Integra Design Ltd.

522,Dhour,Nishatnagar,Turag,Dhaka
(23.892847, 90.377118)

16 May 2022

Observations

MARK		
C-1		*Size: 506mm x 506mm *Reinf: 12-20mmØ *Ring: 10mmØ @ 150 c/c

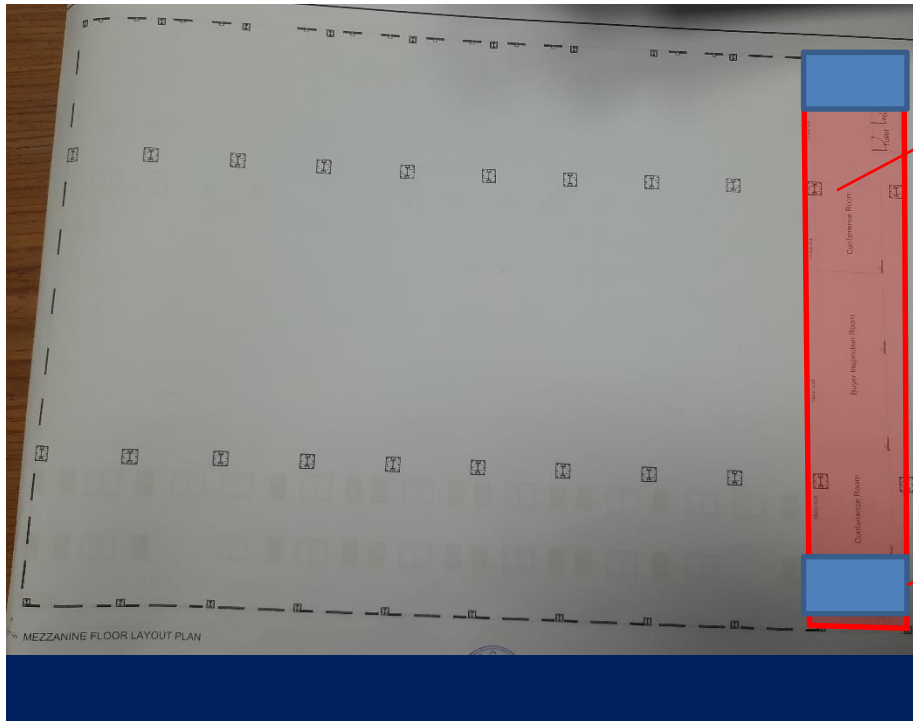
As per provided drawing C1 column was found 375mm X 500mm instead of 500mmX 500mm, Also rebar was found 4 nos (Ø20mm) by ferro scanning instead of 12 nos (Ø20mm). Building engineer is required to check the quantity of rebar and the adequacy of the column.

Onsite typical structural system

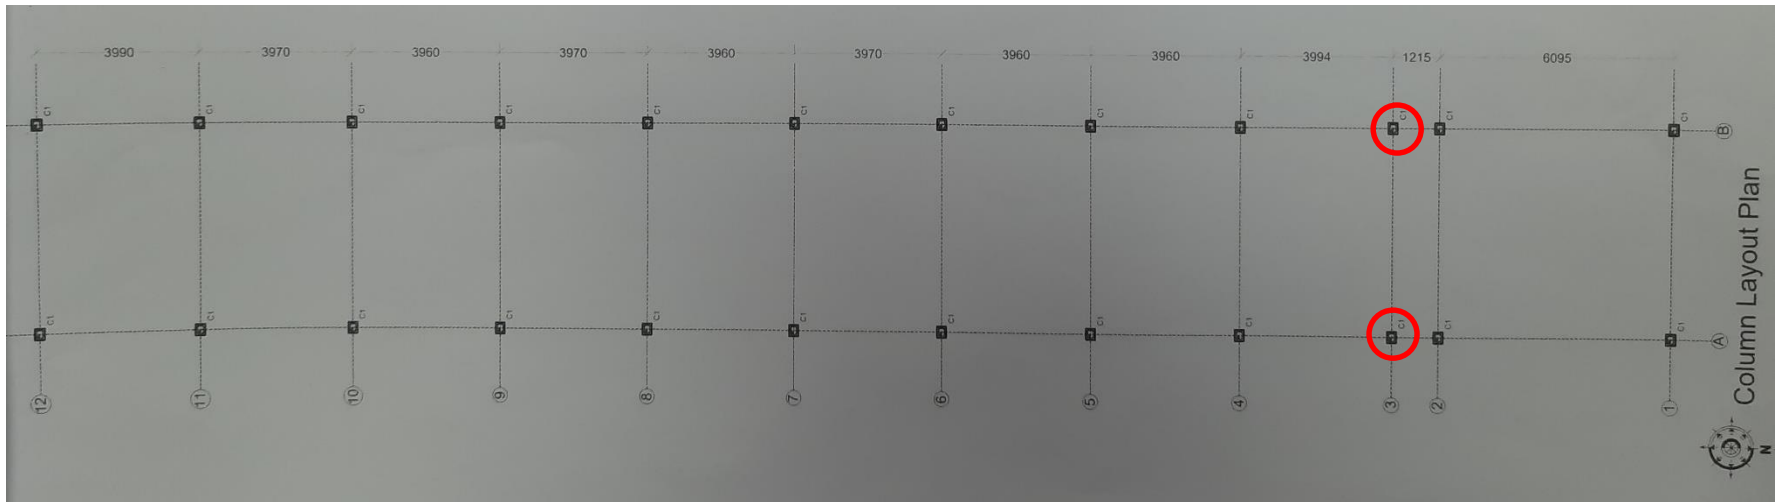
No Structural design and drawing of RC mezzanine floor and steel stair was available.

As per BNBC every building or structure designed shall have its design documents prepared in accordance with the provision of Section 1.9.1. The design document shall include a design report, and a set of structural drawings, which shall be prepared in compliance with section 1.9.1.1 and section 1.9.1.2 as per BNBC. Design report was not found which is required to be prepared in compliance with section 1.9.1.1 (part-6, BNBC).

Column layout

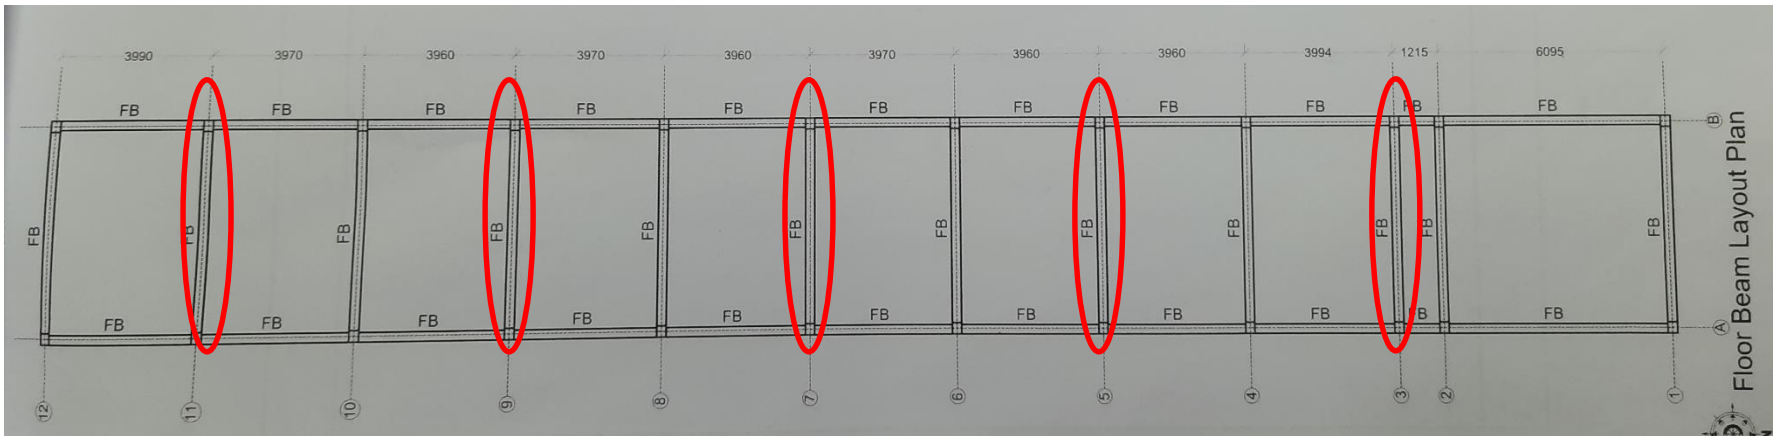
Marked columns were found missing at 1st floor level as per column layout.

Marked beam was found missing at ground floor roof beam layout.

Lateral stability system of roof shed

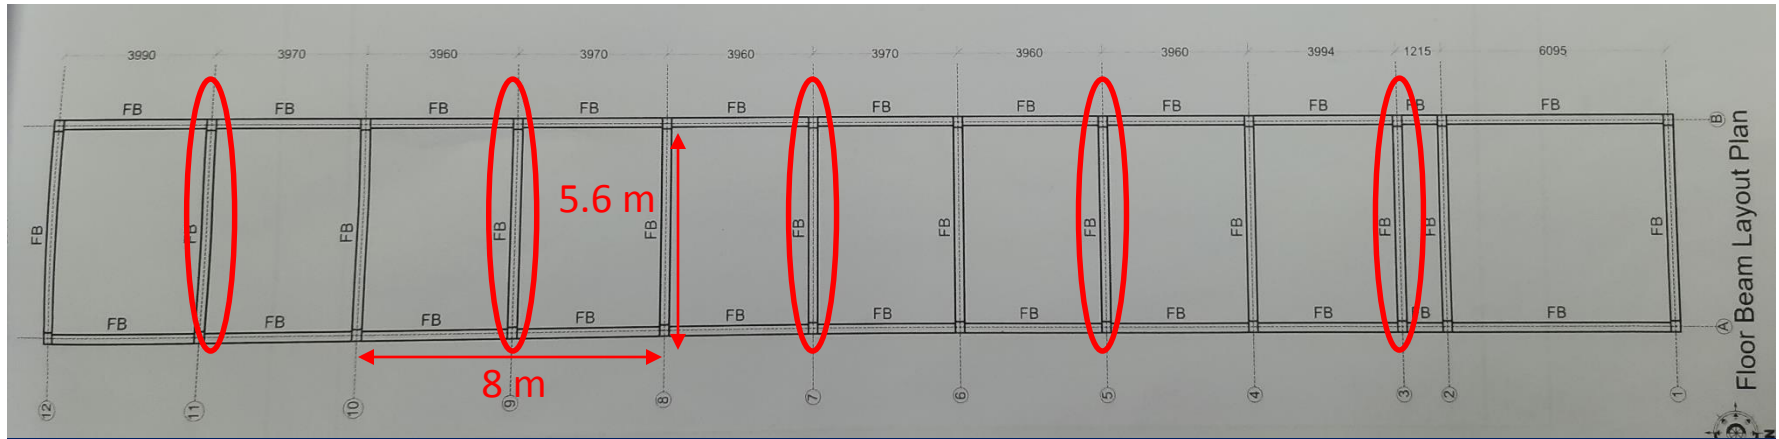
All truss member was found 2L-50mm X 50mm X 4mm which was not as per provided drawing.

Bracing system and load transfer media were not observed on the shed. As part of the Engineering Assessment (EA) building engineer is required to check the lateral stability system of the roof shed.

Beam & slab layout

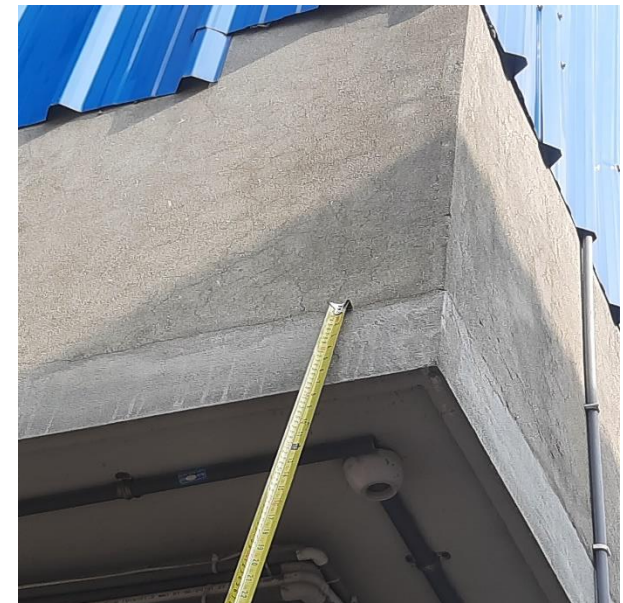
Due to missing of floor beams (as marked in figure) span length was measured 8m X 5.6 m. Slab thickness was measured (T=125mm slab thickness) and no information of rebar was shown in drawing. Building engineer is required to check the adequacy of the slab.

Water ponding on roof slab

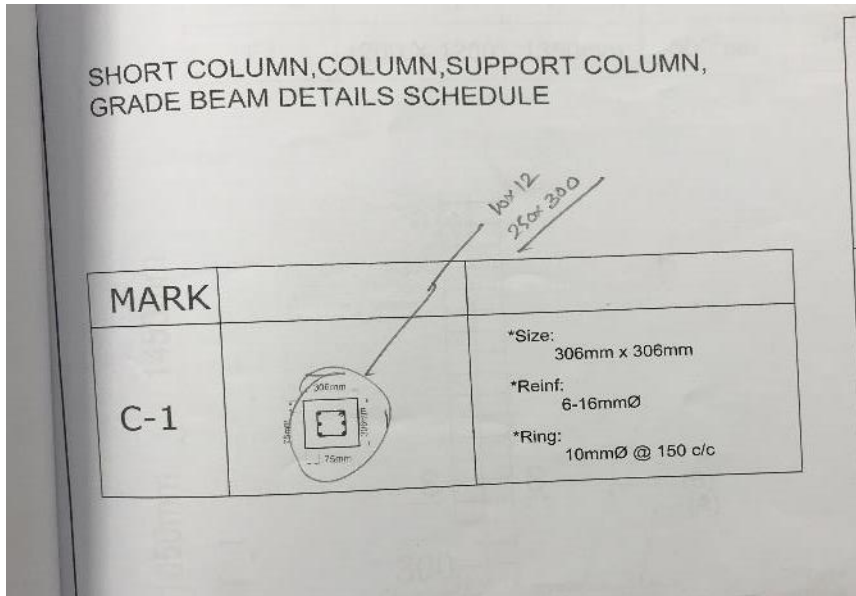
Water ponding & blockage in drainage system was observed on the roof. The factory is required to develop a proper water drainage system on the roof.
